Evaluation of the report of Tokyo Electric Power Company regarding the leakage from the RO-concentrated water storage tank (H6 area C1 tank) at the Fukushima Daiichi Nuclear Power Station

15 April 2015

Nuclear Regulation Authority, Japan

Figure 5 Results of monitoring the drainage ditch and seawater monitoring (extracted from the Secretariat of the NRA's document for a meeting with TEPCO)

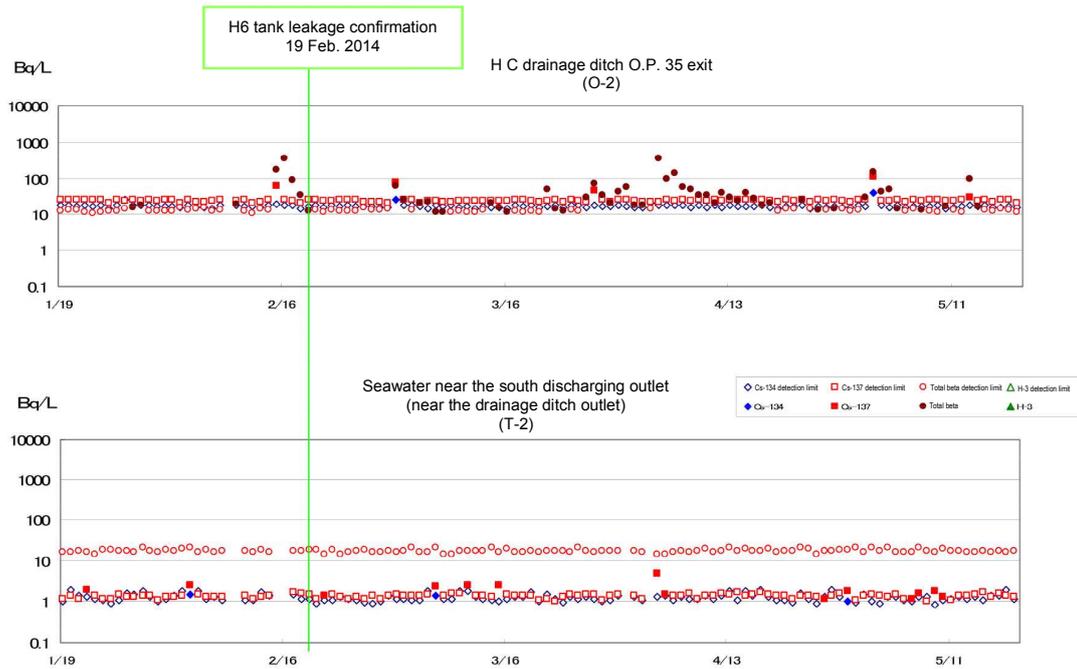
There is no obvious fluctuation in the results of monitoring before and after the leakage occurred in the vicinity of the south discharging outlet (T-2) of the C south drainage ditch. The NRA therefore concludes that this event did not cause ocean contamination that raises any concerns about effects on health or the environment (refer to Figure 5).
